Memorandum

TO: EPA REGION 6; EPA HEADQUARTERS
FROM: JEREMY FISHER, NIDHI SANTEN, AND SPENCER FIELDS
DATE: SEPTEMBER 8, 2015
RE: ASSESSING THE DECEMBER 2014 ERCOT REPORT ON ENVIRONMENTAL REGULATIONS

Figure 1. Texas Clean Power Plan Rate Targets (lbs CO₂/MWh) under proposed and final rule

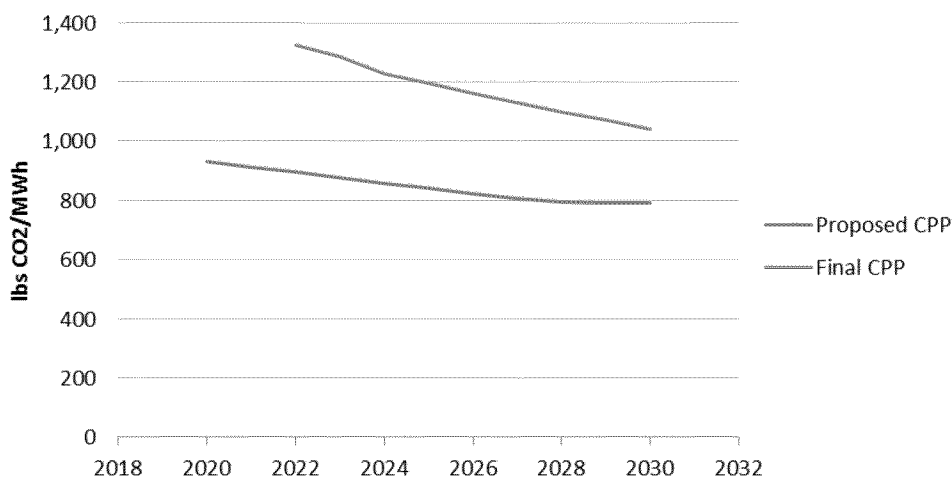
There are a number of notable differences between the proposed Clean Power Plan rule modeled in the ERCOT study and the finalized rule of August 2015, each of which Synapse believes will only lessen any reliability challenges ERCOT cites.¹⁰

- First, the compliance period for the Clean Power Plan has shifted, and the first year of compliance is now 2022 instead of 2020. While there are incentives for early actions, this change should largely alleviate concerns about reserve margin size because Texas will now have an additional two years to have energy efficiency and other measures materialize before compliance begins.
- Second, ERCOT's requirements under the final Clean Power Plan are substantially less stringent than under the proposed rule. As shown in Figure 1, below, the compliance requirement is over 40 percent less stringent at the start of compliance, and over 30 percent less stringent in the final compliance year. One could expect that this change in requirement will result in fewer economic coal unit retirements.
